DOCUMENT 00911

**ADDENDUM NUMBER 1**

Issued: December 1, 2011

**Service Center Relocation  
(2025 Aviation Boulevard)**

DRAWING NUMBER: A-6 SHEET 15 OF 56

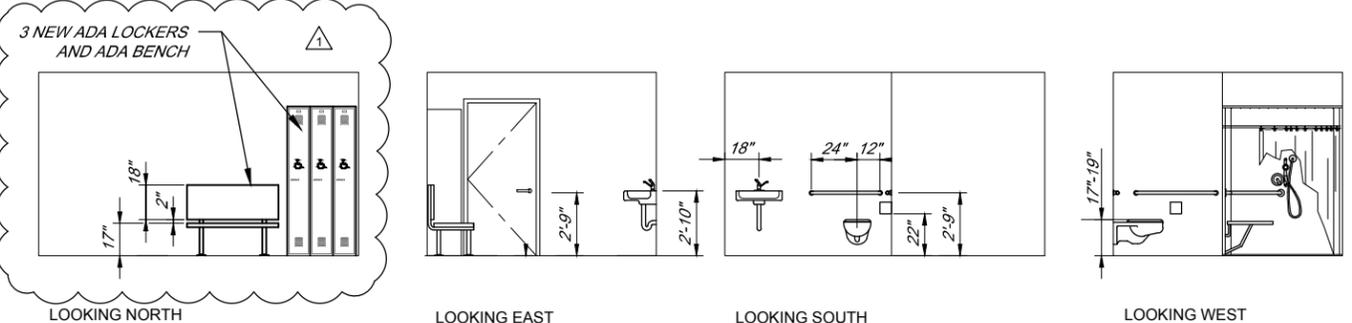
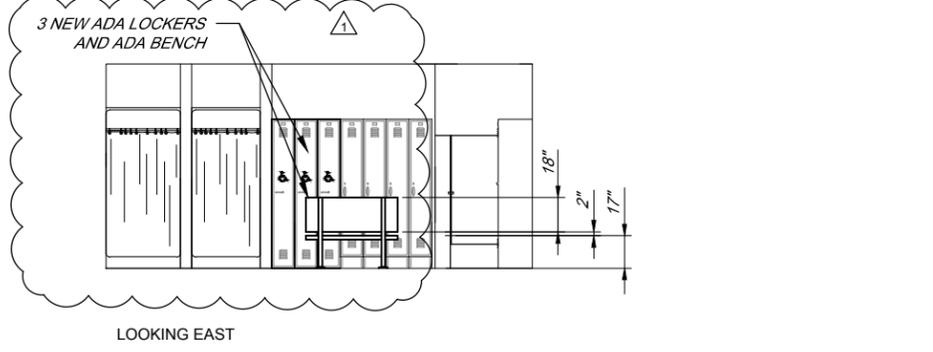
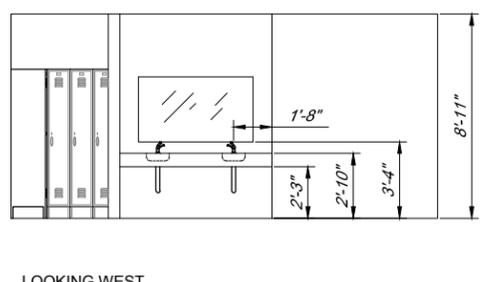
2. At the (E) building, room 107, sheet A-6 shows 7 lockers and one bench, is this new? What about the other lockers that are shown in this room (A-7), are these to be new lockers or are they (E) to remain?

3. Room 105 shows only three lockers and one bench (A-7), I am assuming these are new lockers and bench.

3. It appears that the lockers in room 105 and the benches in 105 and 107 are new. However it looks like the lockers in room 107 are existing to remain. Please confirm this.

5. The elevations of the upper cabinets on plan sheet A-6 appear to be showing the doors as glass. The specifications for the casework do not address any glass. Please clarify the door material for the upper cabinets.

- C. Drawing Number A-4:
  - 1. Insert the following as NOTE #3:  
3. Ventilate attic space per Building Code
- D. Drawing Number A-6:
  - 1. Delete and replace with attached Drawing number A-6 marked "12-01-11, ADDENDUM No. 1."

SERVICE CENTER RELOCATION (2025 AVIATION BOULEVARD)  
**EXISTING SERVICE CENTER FLOOR PLAN AND FINISH SCHEDULE**

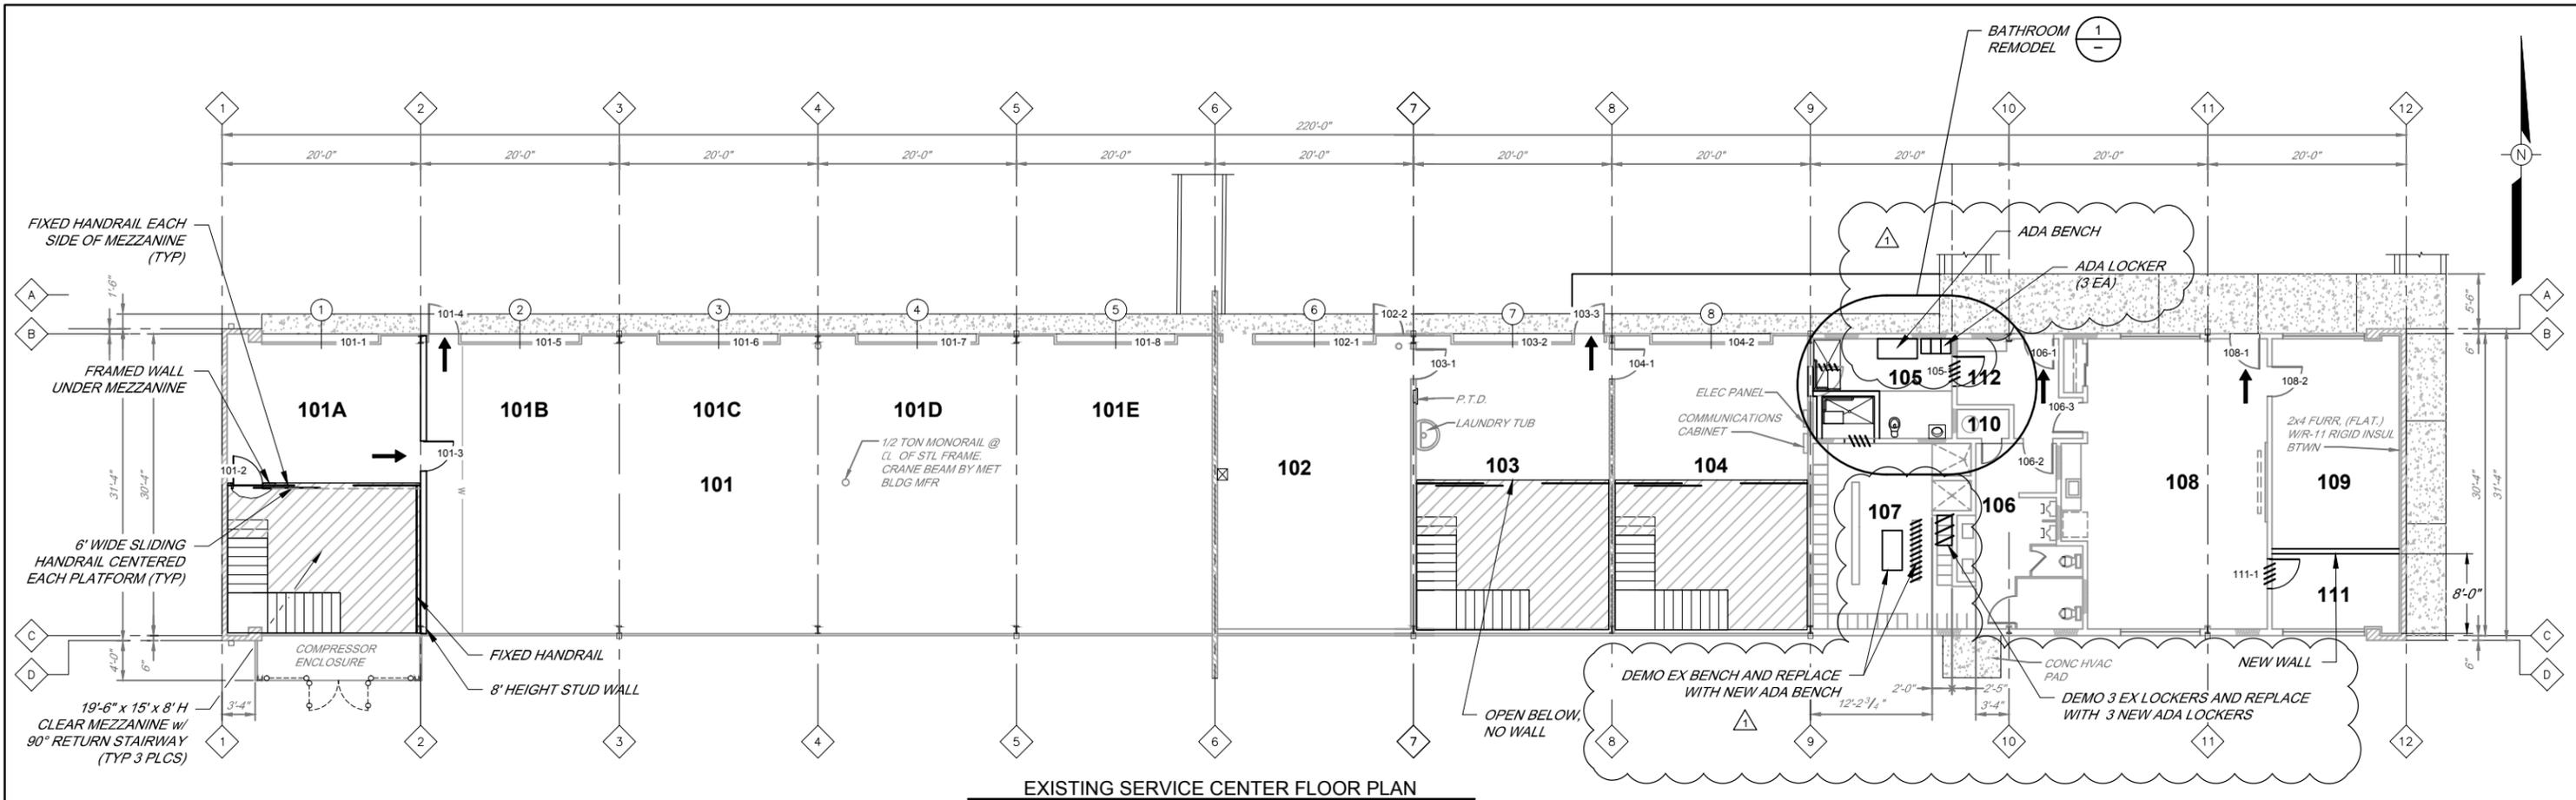
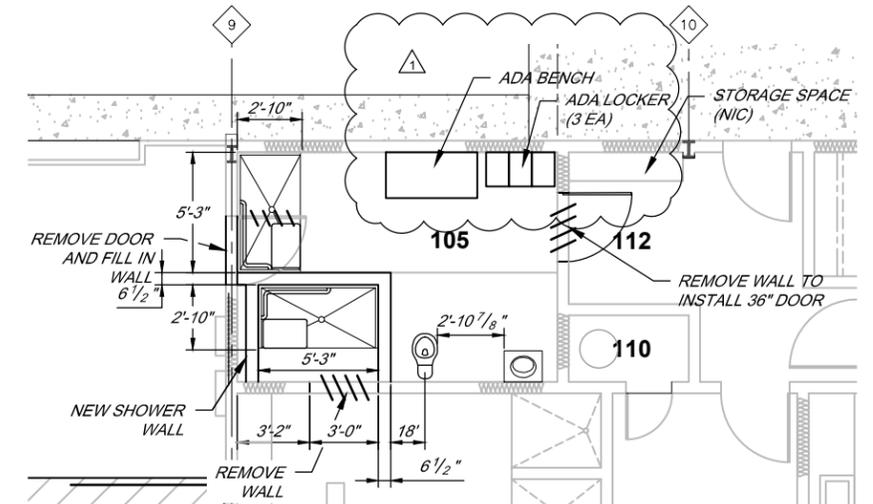
6. The door schedule on sheet A-2 notes door 128-1 as full louvered. Please confirm that the women's restroom door is to be full louvered.

- A. Drawing Number S4:
  - 1. Change Detail #9 to read Detail #1:
- B. Drawing Number A-2:
  - 1. Modify Door Schedule, Room # 128, as follows:

Room#	Door#	Width	Height	Type	Hardware Group
128	128-1	3'	7'	<del>M/PH/FL</del> <u>M/PH</u>	Group 7

SCALE: 1/8" = 1'-0"	DATE: 9/28/2011																												
DRAWN: SMG																													
REVIEWED:																													
<p>FILE NAME: 7449_E-212.dwg      CONTRACT NUMBER: 0-706-7 #01A</p>																													
<p>DRAWING NUMBER: E-212      SHEET 31 OF 56</p>

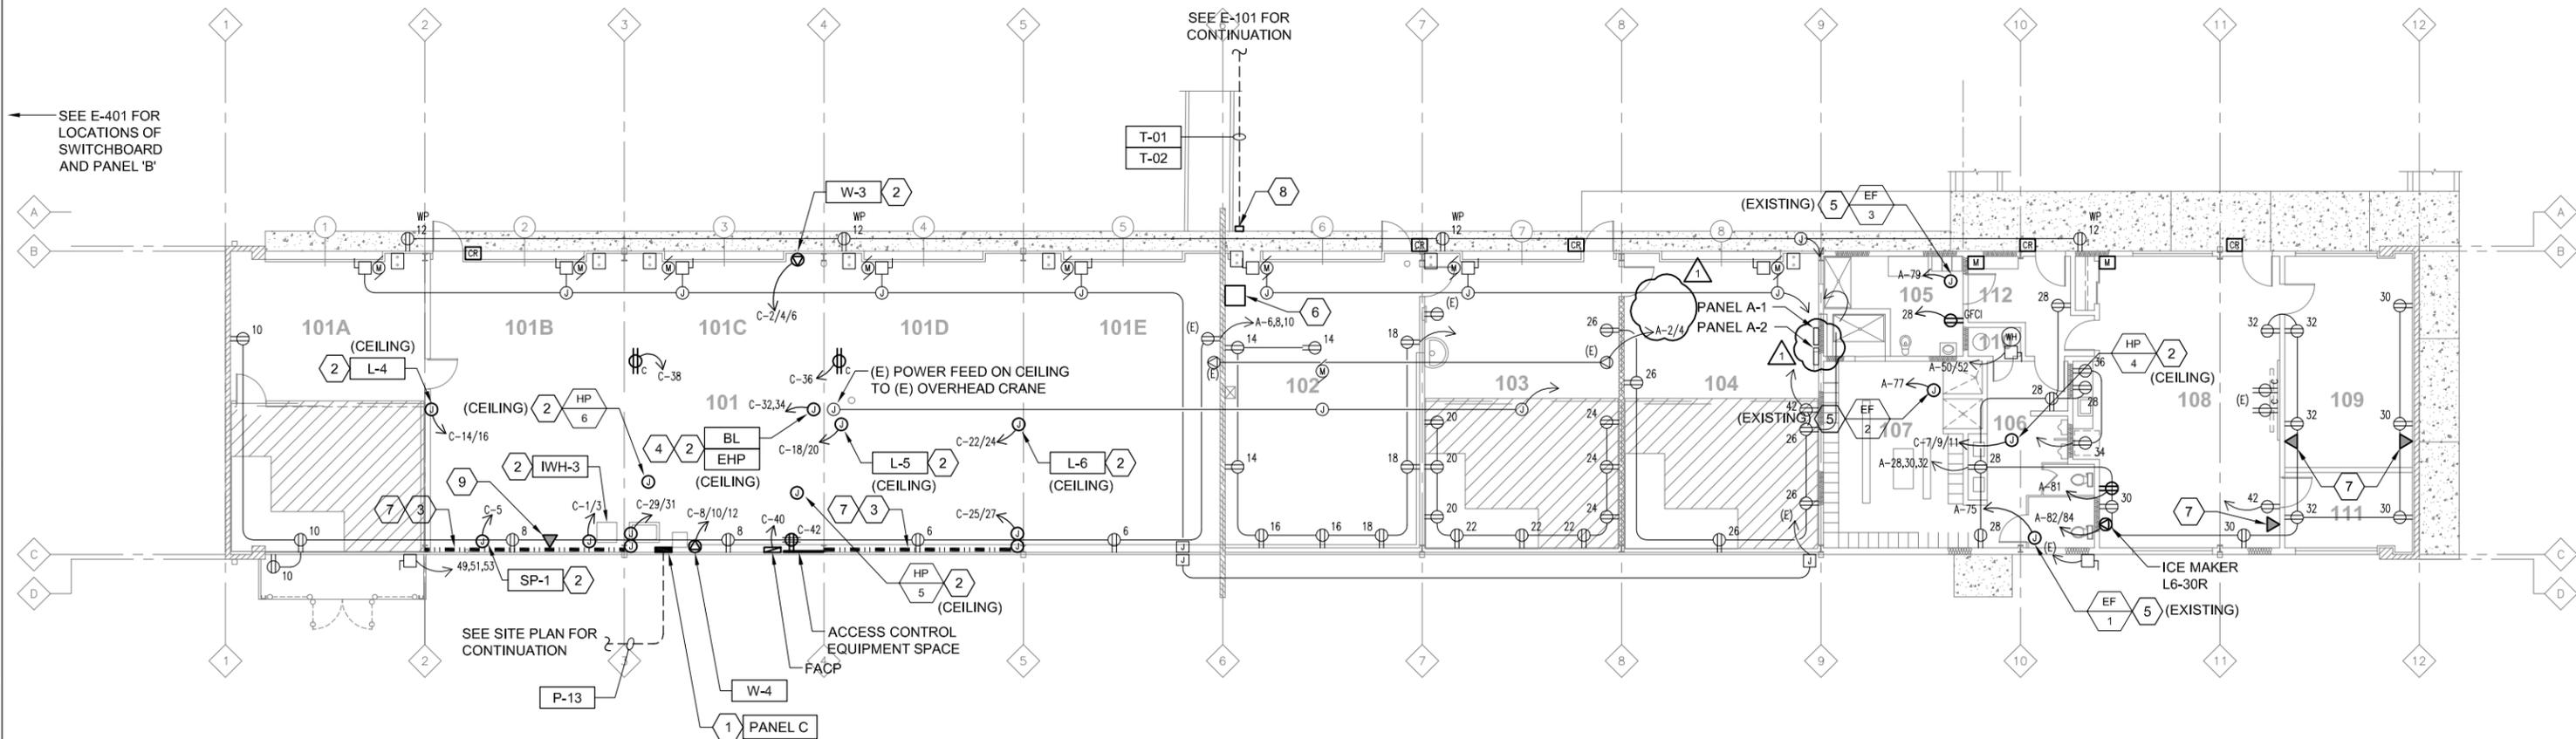
1. On sheet E-212, panel A1 has a sheet note 1 referring to changing this panel to a new one, but on sheet E-601 and E-602 this panel is shown as existing and not being replaced. Please let me know if it will be new or existing. Also, this panel is a 2 section panel A1 and A2.

- G. Drawing Number E-211:
  - 1. Delete and replace with attached Drawing number E-211 marked "12/01/11, ADDENDUM NO. 1."
- H. Drawing Number E-212:
  - 1. Delete and replace with attached Drawing number E-212 marked "12/01/11, ADDENDUM NO. 1."

SERVICE CENTER RELOCATION (2025 AVIATION BOULEVARD)	
EXISTING SERVICE CENTER	
LIGHTING PLAN	
FILE NAME:	7449_E-213.dwg
CONTRACT NUMBER:	0-706-7 #01A
DRAWING NUMBER:	E-213
SHEET	32 OF 56

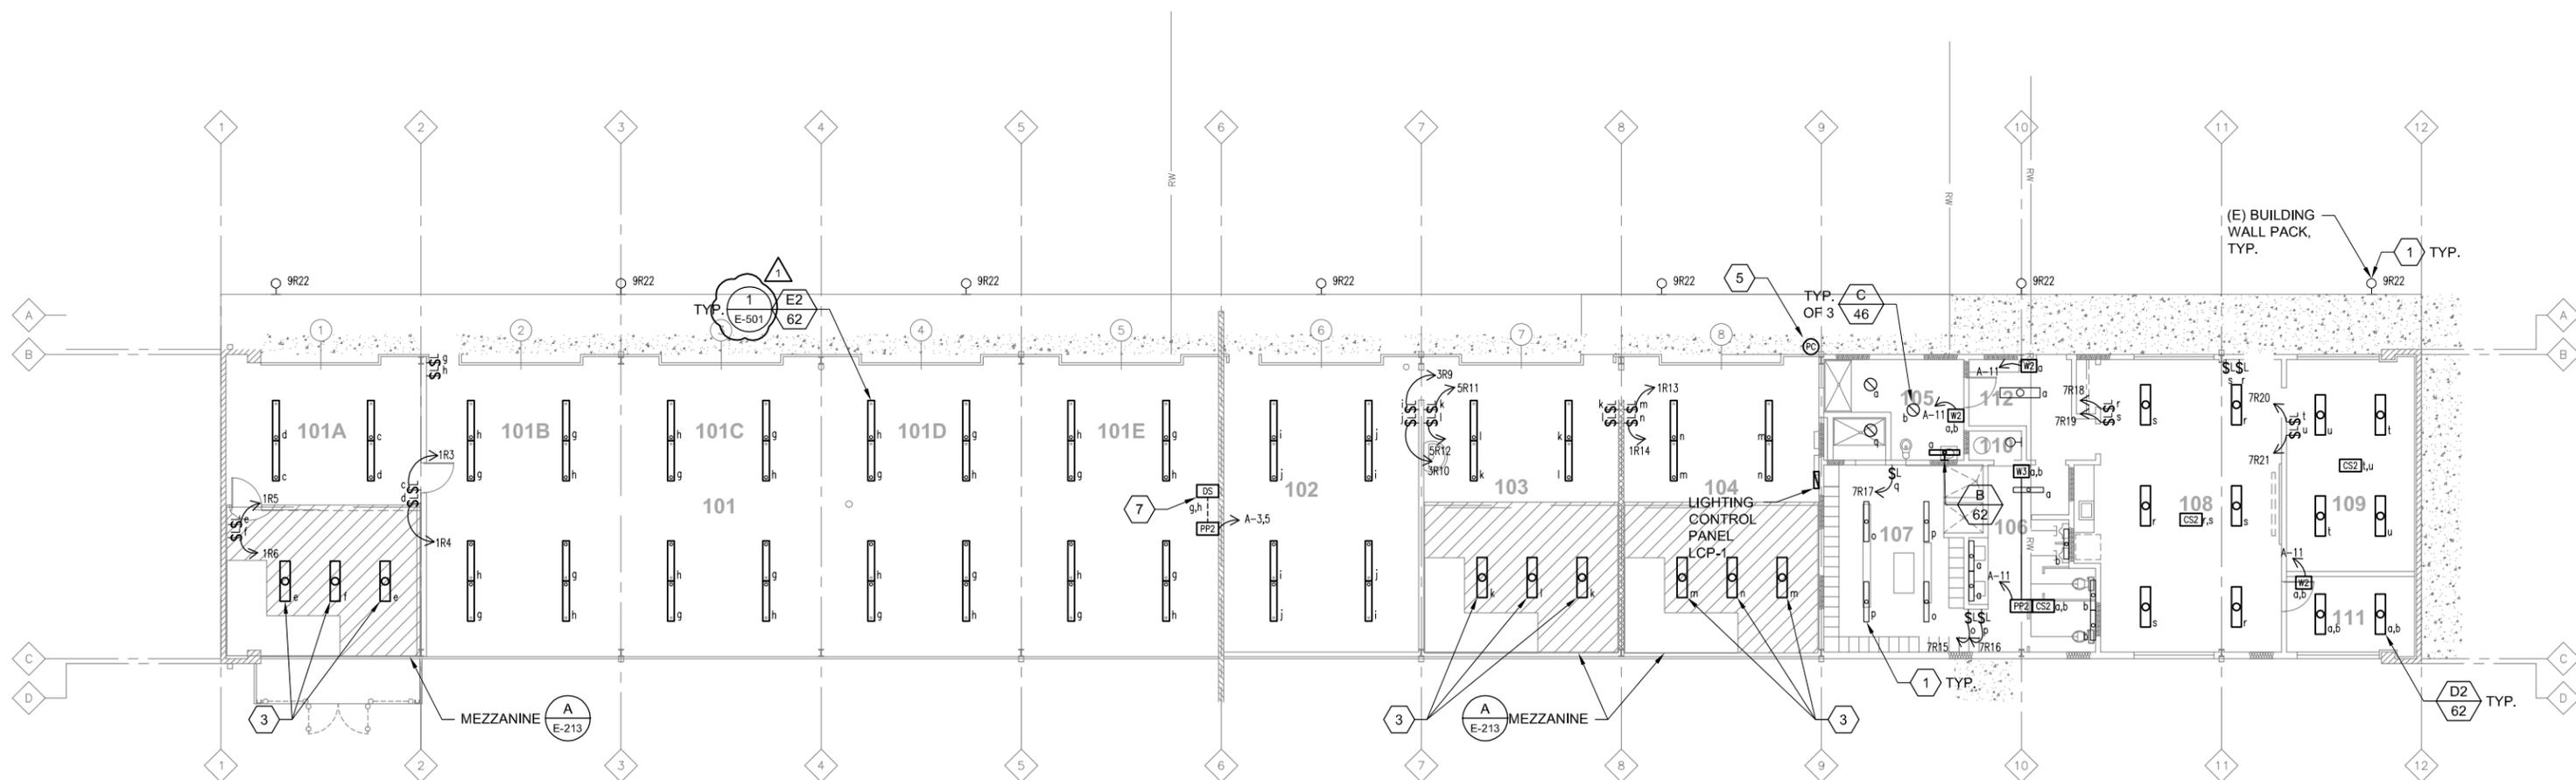
1. I am not following the details on the electrical sheets. For example, sheet 32 (E213), there is a detail 1/E5.1, there is no E 5.1.

- I. Drawing Number E-213:
  - 1. Delete and replace with attached Drawing number E-213 marked "12/01/11, ADDENDUM NO. 1."
- J. Drawing Number E-221:
  - 1. Delete and replace with attached Drawing number E-221 marked "12/01/11, ADDENDUM NO. 1."
